UNITED STATES PATENT AND TRADEMARK OFFICE

APPLICATION NO.	FILING DATE	FIRST NAMED INVENTOR	ATTORNEY DOCKET NO.	CONFIRMATION NO.
10/722,156	11/24/2003	Raj B. Apte	D/A3536	6774

Office Action Summary

DETAILED ACTION

See Figure 9.

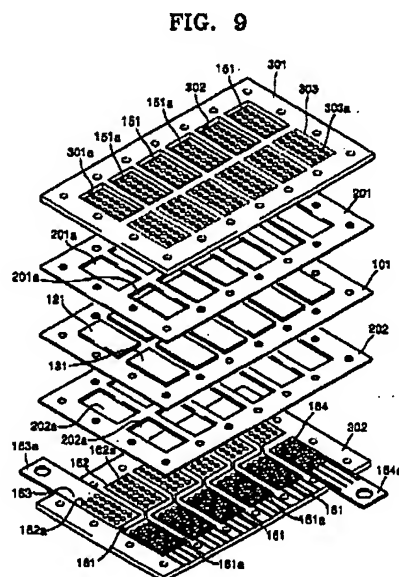
With respect to **claim 27**, Choi teaches a fuel cell comprising: an electrolyte (col. 8, lines 25-35) having a first side; a manifold cover (201) that is in contact with the electrolyte (101), the manifold cover (201) and electrolyte (101) together form two manifolds, a first manifold including an anode (121), and a second manifold including the cathode (131), wherein the two manifolds are both on the first side of the electrolyte.

FIG. 6

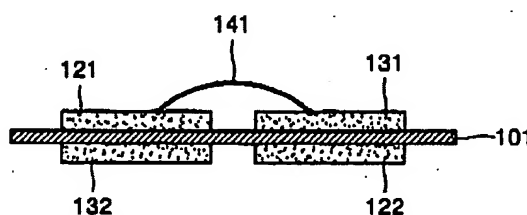
With respect to **claims 29 & 32**, the anode (121) and the cathode (131) are in a first plane, the first plane is approximately parallel to the first side of the electrolyte (101). See Figure 6.

FIG. 2

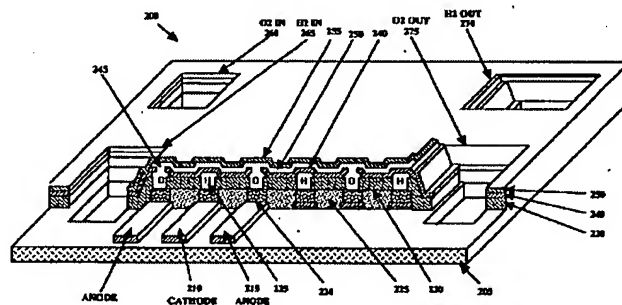
With respect to **claim 27**, Potter teaches a fuel cell 200 comprising: an electrolyte (225) having a first side; a manifold cover (205) that is in contact with the electrolyte (225), the manifold cover (205) and electrolyte (225) together form two manifolds, a first manifold including an anode (215), and a second manifold including the cathode (210), wherein the two manifolds are both on the first side of the electrolyte. See Figure 2, and paragraph 49.

With respect to **claims 29 & 32**, the anode (121) and the cathode (131) are in a first plane, the first plane is approximately parallel to the first side of the electrolyte (101). See Figure 2.

With respect to **claim 34**, the first side of the electrolyte (225) includes a first indentation and a second indentation, wherein each include an anode and cathode, respectively. See Figure 2 and paragraph 49.

With respect to **claim 36**, the manifold cover is in contact with an edge of the electrolyte indentations containing electrodes. See Figure 2 and paragraph 49.
